SUBJECT: REQUESTS CHANGE IN TECH SPECS TO REFLECT DELETION OF  
 PRESSURIZER PRESSURE SIGNAL, W/SUPPORTING DOCUMENTATION &  
 CLASS III AMEND FEE.

H. B. ROBINSON STEAM ELECTRIC PLANT, UNIT NO. 2  
DOCKET NO. 50-261  
LICENSE NO. DPR-23  
REQUEST FOR LICENSE AMENDMENT - PRESSURIZER PRESSURE SIGNAL

H. B. ROBINSON (CPL) PRESSURIZER  
LEVEL/PRESSURE COINCIDENCE  
MODIFICATION SAFETY EVALUATION

# Low Pressurizer Pressure Coincident with Low Pressurizer Level

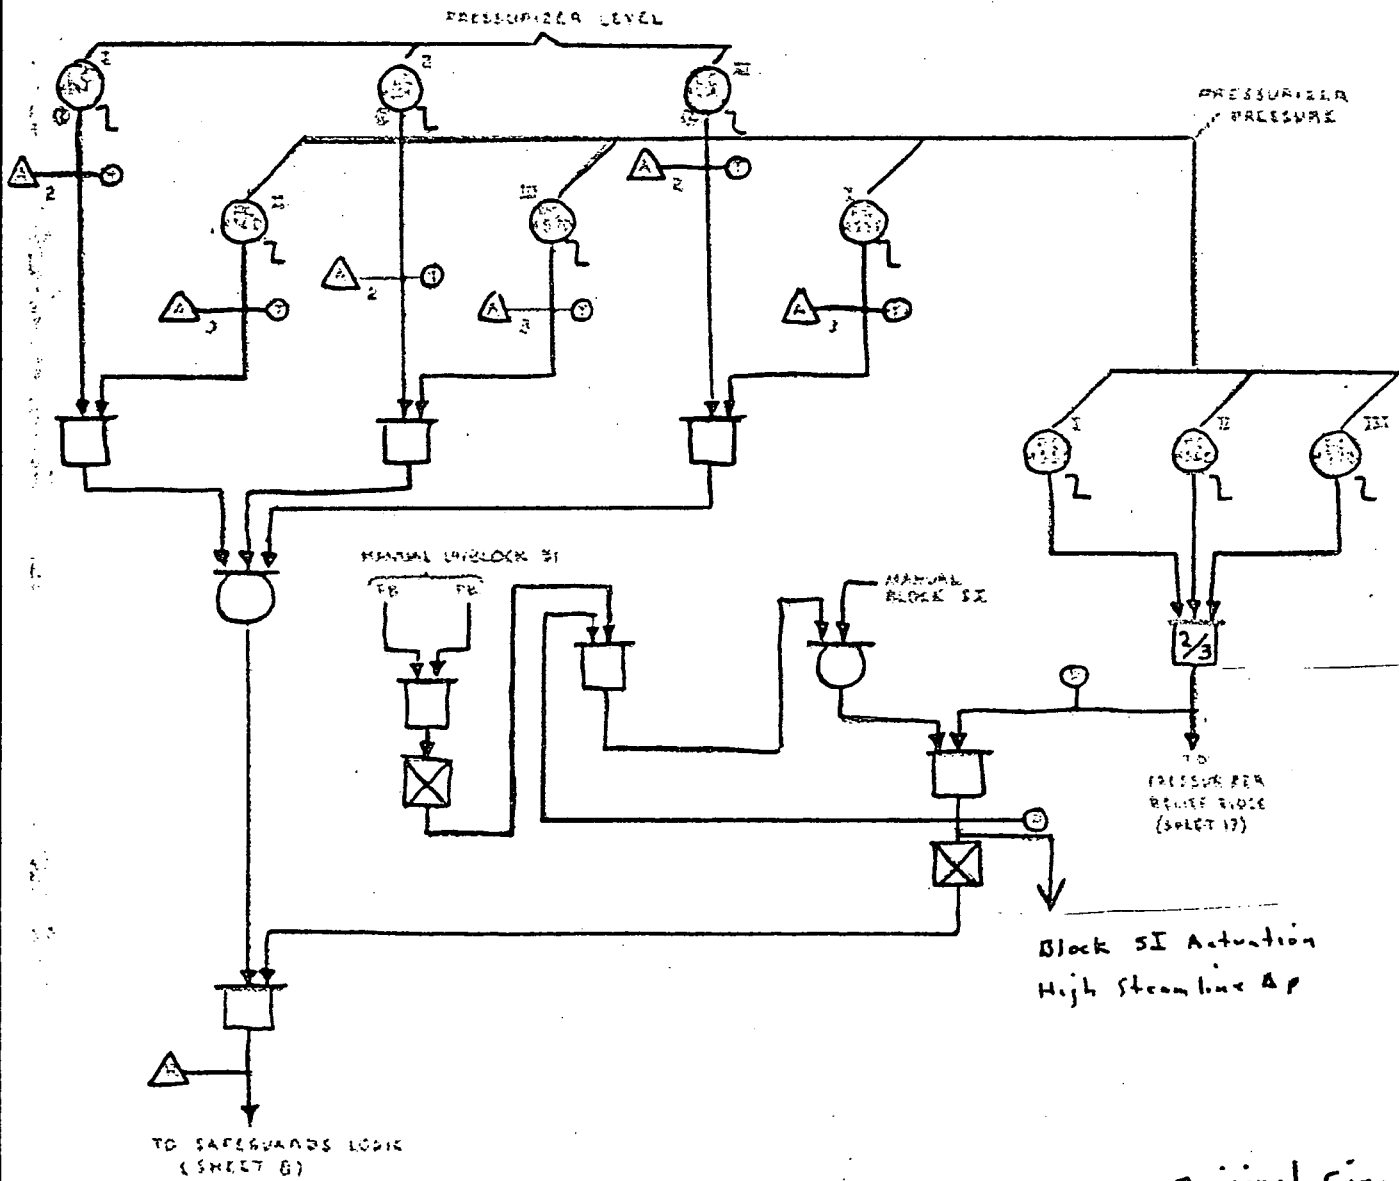
In accordance with the Code of Federal Regulations, Title 10, Part 50.90 and Part 2.101, Carolina Power & Light Company (CP&L) hereby requests a revision to the Technical Specifications for its H. B. Robinson Steam Electric Plant, Unit No. 2. This request reflects changes brought about by the deletion of the Pressurizer Level signal from the, "Low Level in Coincidence with Low Pressurizer Pressure," safeguards actuation signal and converting the three channels of pressure protection into a two out of three logic as prompted by IE Bulletin No. 79-06A. A diagram of the change is attached.

original circuit

### Revised circuit

Westinghouse has performed a safety evaluation of the safety injection actuation logic modifications for application to the H. B. Robinson Nuclear Unit. The existing logic will be modified by deleting the low pressurizer pressure coincident with low pressurizer level actuation logic and converting the protection system to a two-out-of-three low pressurizer pressure actuation only.
